Product/Process Change Notice - PCN 23_0053 Rev. -

PCN Title:	AD4695/6/7/8 Family Datasheet Specification Update
Publication Date:	21-Apr-2023
Effectivity Date:	21-Apr-2023 <i>(the earliest date that a customer could expect to receive changed material)</i>
Revision Description:	Initial Release

AD469X PCN for DC Spec and AVDD Extension

NEW Input Leakage Current TPCs

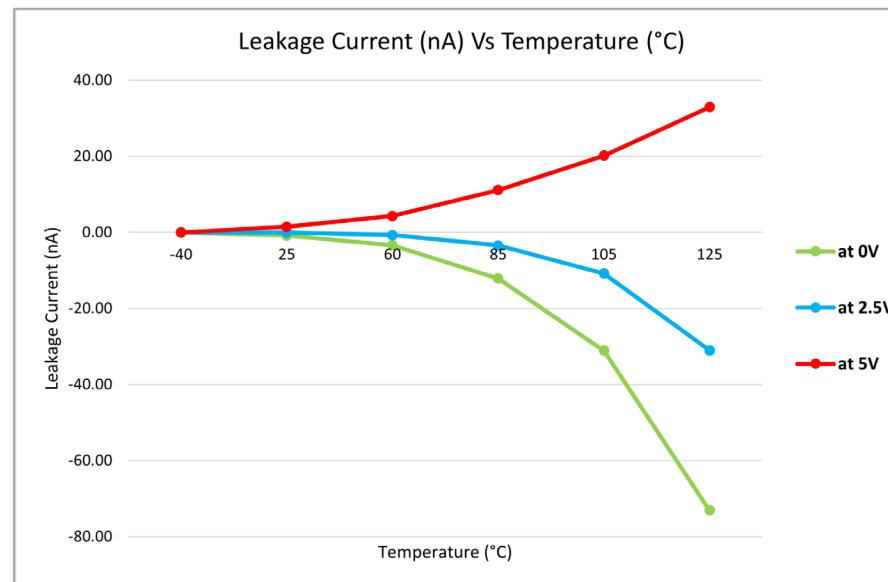
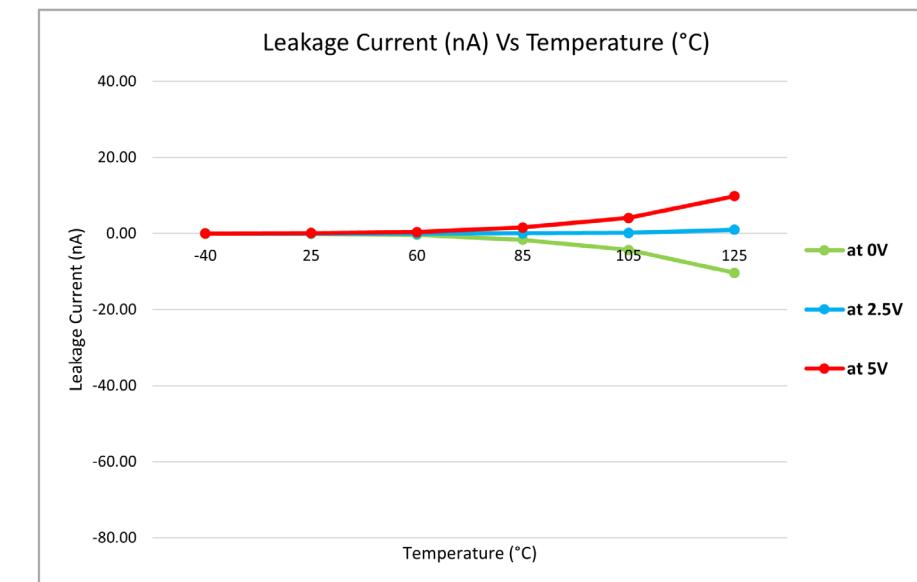
► Leakage Current vs. Temperature

- For input voltages = 0 V, 2.5 V, and 5 V

► Slotting into Figure 63 for convenience

- Would have been better to group with other Analog Input TPCs but would disrupt the document too much...
